Product Change Notification / MFOL-10XVVK480

CCB 3947.001 Final Notice: Qualification of MMT as an additional assembly site for selected PIC32MM00xx device family available in 20L QFN (4x4x0.9mm) package.

CCB 3947.001

PCN# MFOL-10XVVK480

Lead Frame Comparison

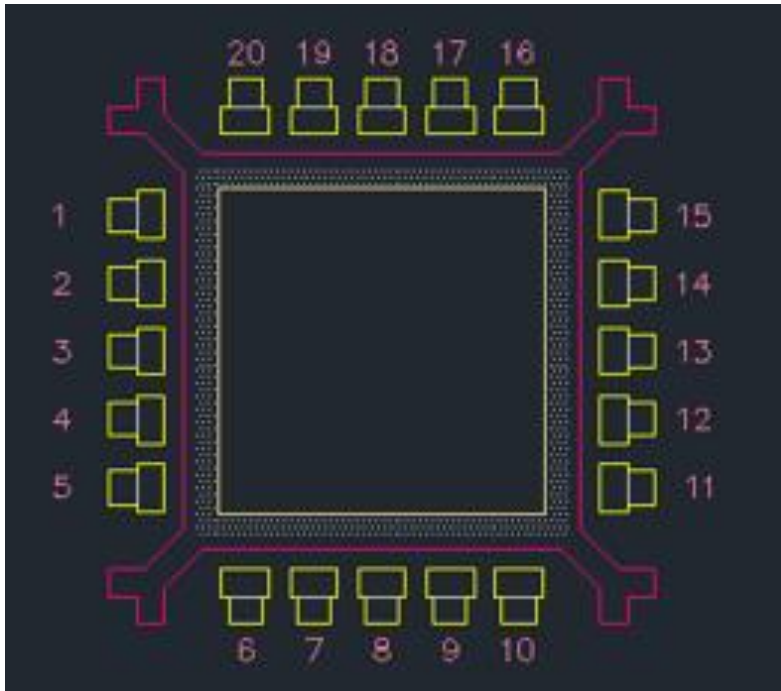
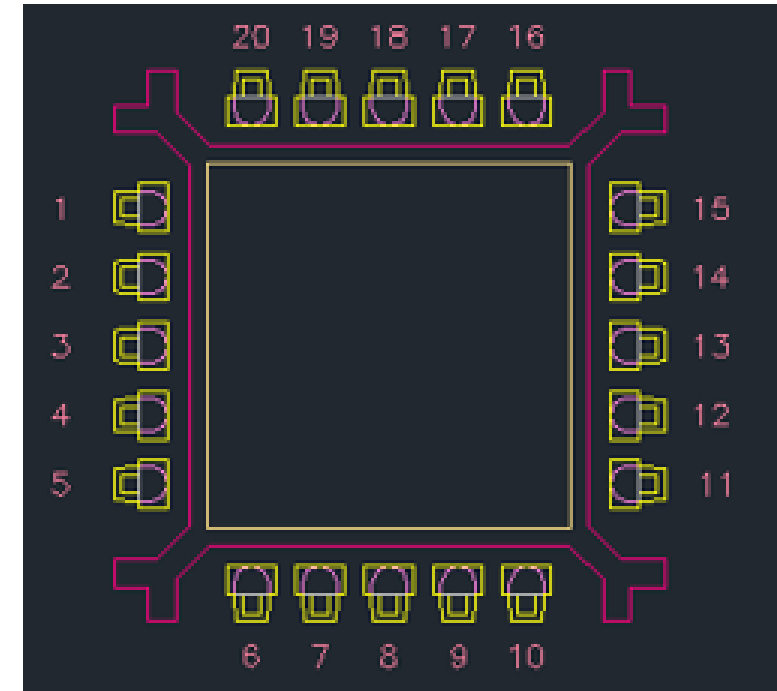
Assembly Site	UTAC Thai Limited (UTL-1) LTD. (NSEB)	UTAC Thai Limited (UTL-1) LTD. (NSEB)	Microchip Technology Thailand (Branch) (MMT)
Wire Material	Au	Au	Au
Die Attach Material	8600	8600	3280
Molding Compound Material	G700LTD	G700LTD	G700LTD
Lead-Frame Material	EFTEC-64T	EFTEC-64T	A194
Lead-Frame Paddle Size	114 x 114 mils	114 x 114 mils	114 x 114 mils
DAP Surface Prep	Ag ring plating	Ag ring plating	Bare Cu
	See Pre and Post change comparison.
